DRB CASE ACTION LOG - BLUE SHEET

Project #: 1003479

Project Name: LAND OF ST ANTHONY ORPHANAGE

TO: Jack Cloud, DRB Chair
FROM: Carrie Barkhurst, Planner
SUBJECT: Project # 1003479 – Third DRB Review Memo
DATE: July 12, 2013

OPTION 1

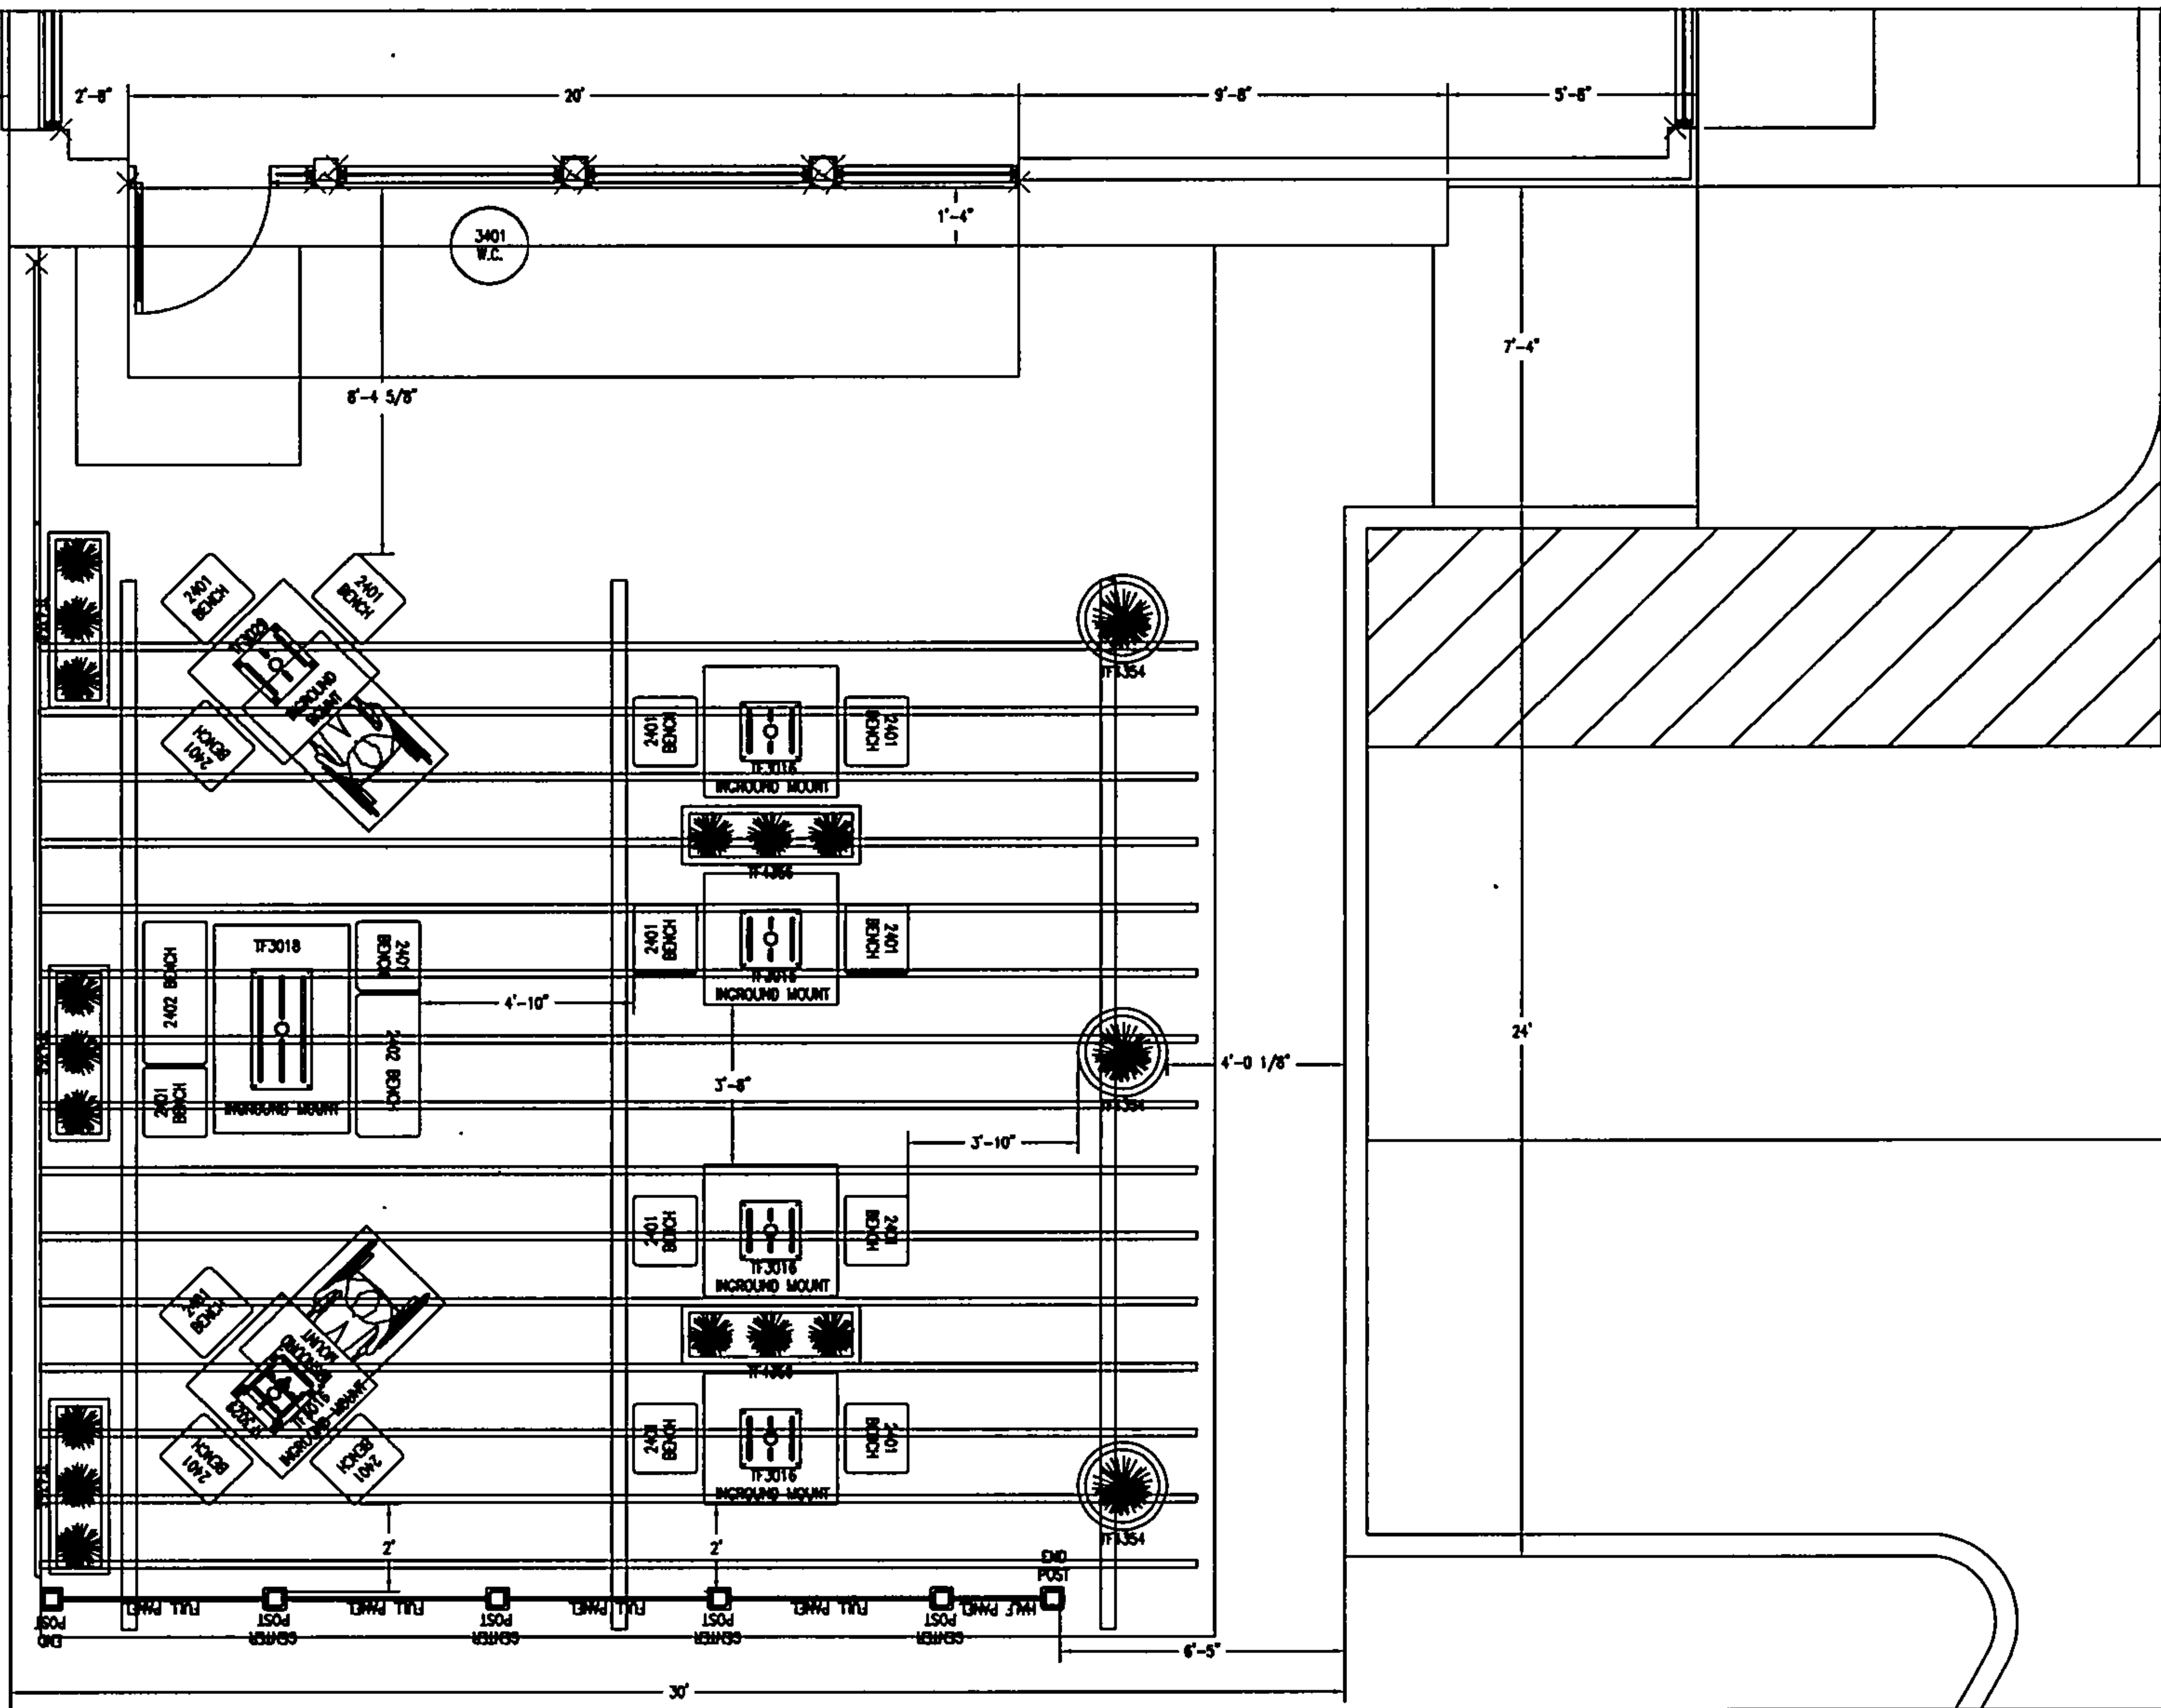
NOTE:
 ALL DIMENSIONS OF PATIO AREA NEED TO BE VERIFIED TO AVOID INSTALL AND ADA ISSUES. EXACT DIMENSIONED PLAN NOT GIVEN. ALL ACCESSIBLE PATHS TO ACCESSIBLE PATIO SEATING NEED TO BE ADA COMPLIANT AND MAINTAIN NO GREATER SLOPE OF 2% IN ALL DIRECTIONS

OPTION 2

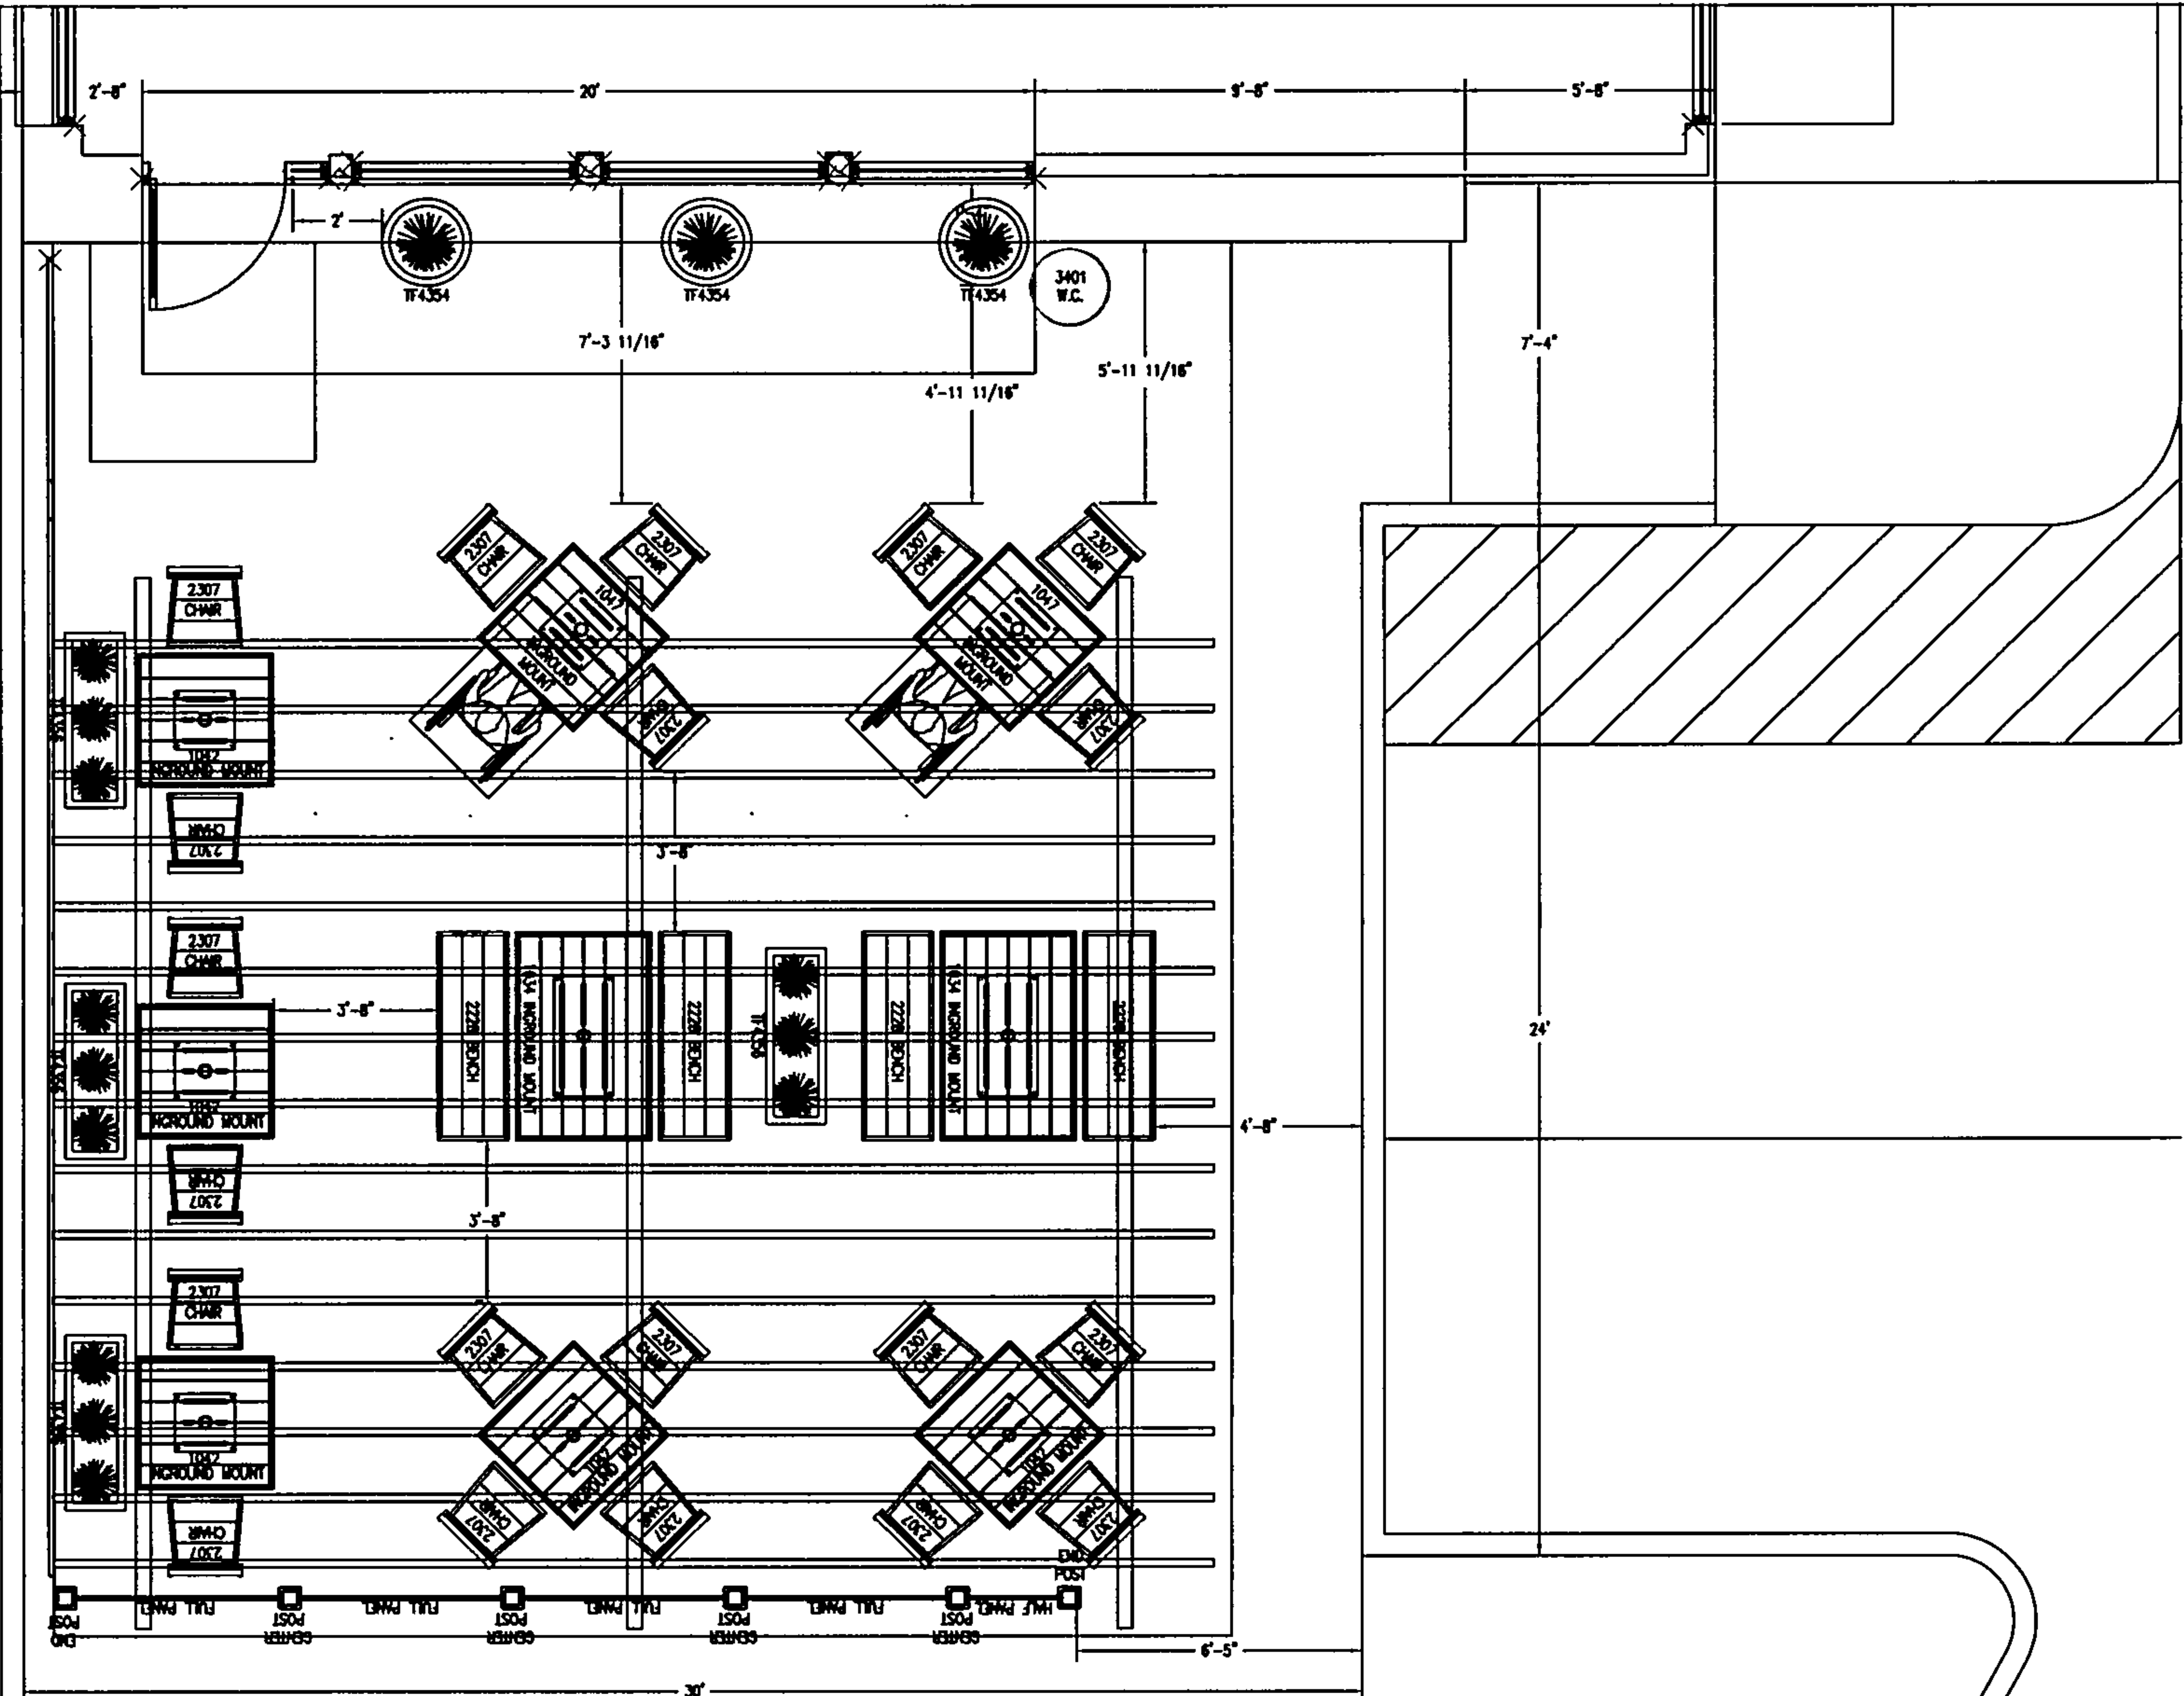
NOTE:
 ALL DIMENSIONS OF PATIO AREA NEED TO BE VERIFIED TO AVOID INSTALL AND ADA ISSUES. EXACT DIMENSIONED PLAN NOT GIVEN. ALL ACCESSIBLE PATHS TO ACCESSIBLE PATIO SEATING NEED TO BE ADA COMPLIANT AND MAINTAIN NO GREATER SLOPE OF 2% IN ALL DIRECTIONS
